Barry Waterfront SPG

Appendix B - Summary of comments and actions

Summary of Comments Received on Draft Development Brief March 2009

Figure 12: Character Areas

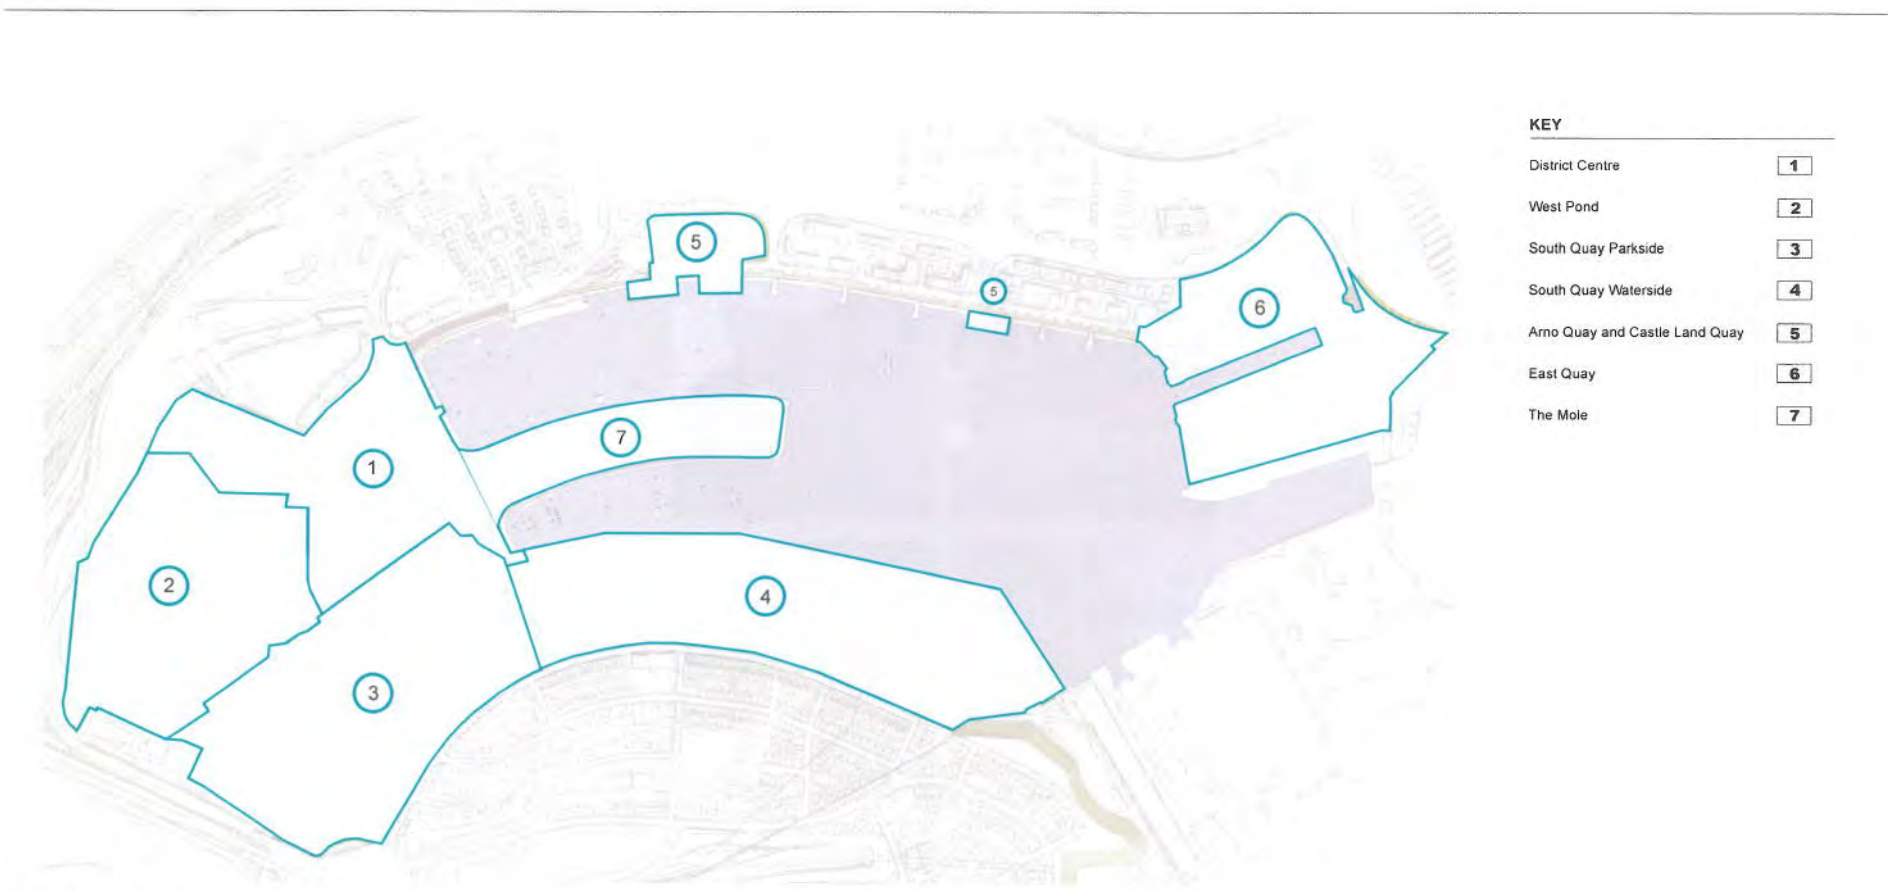
13	Para 5.12 and Figure 12	WYG	The College site is in connection with the 'Triangle Site' not the steam railway car park - this scheme is no longer proceeding. What is intended for the "Quays"?	12/03/2009	Amended. Quays proposed as part of landscaped public realm.
14	Para 5.12 and Figure 12	VoG	Remove paragraph and replace with: "This is an extensive area of open land at a key location immediately adjacent to this phase of the Barry Waterfront development".	09/03/2009	Addressed at Para 5.15.
15	Para 5.13	VoG	Additional text for key challenges and influences suggested	09/03/2009	Additional text included as appropriate.

Figure 13: Strategic Masterplan

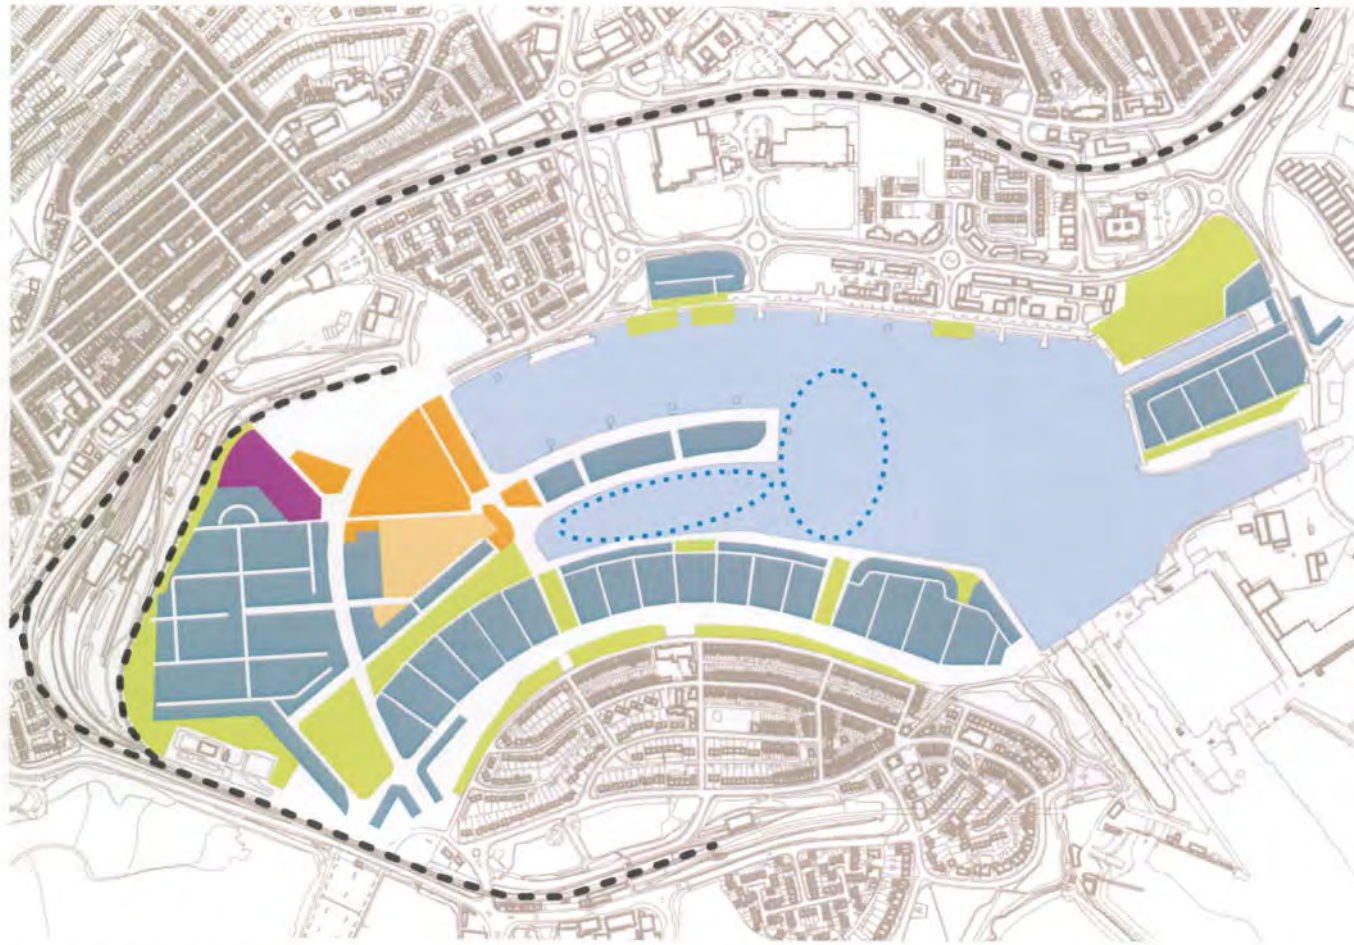
Section of Brief	By	Item	Date raised	Action
1 Figure 10	VoG	Supermarket parking area shown on the plan is overly prescriptive.	19/08/2009	Revised accordingly
2 Figure 13	VoG	Arno Quay is identified as residential should allow some potential for A3 use.	19/08/2009	This point is addressed in paragraph 6.21
